Subject: NOISE FROM FRONT OF VEHICLE / STABILIZER CONTROL LINK BROKEN	Bulletin No: 02-005/08
	Last Issued: 10/23/2008

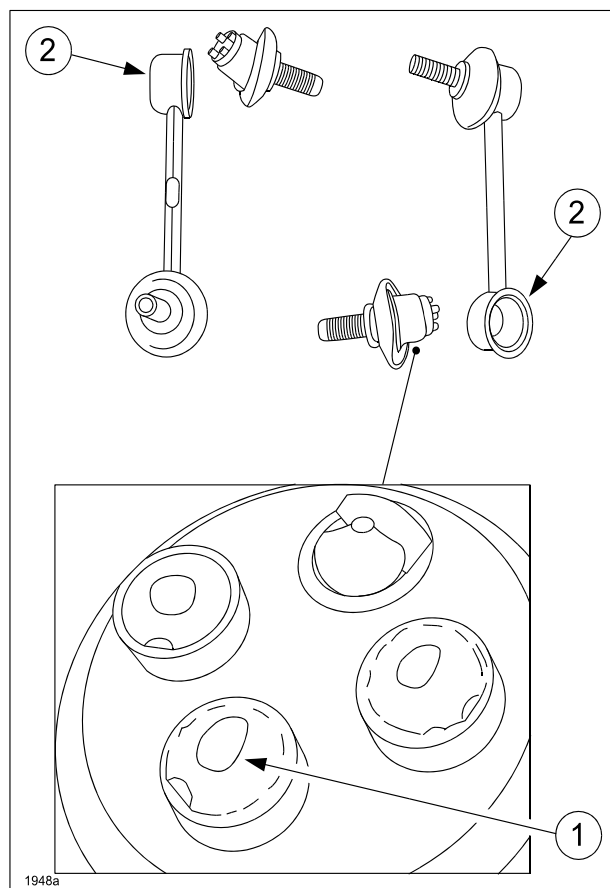
Some customers may complain of an unusual noise from the front of the vehicle. The plastic insert connecting the stabilizer control link ball joint to the control link may crack (1) and become separated (2).

As a result, the stabilizer bar is not connected to the front lower arm, causing the noise. Steering and/or han-

As a mass-production change, the design of the front stabilizer control link has been modified.

1. Verify customer concern.
2. Replace left and right stabilizer control links with modified ones. Refer to Workshop Manual section 02-13 FRONT STABILIZER REMOVAL / INSTALLATION.
3. Verify repair.
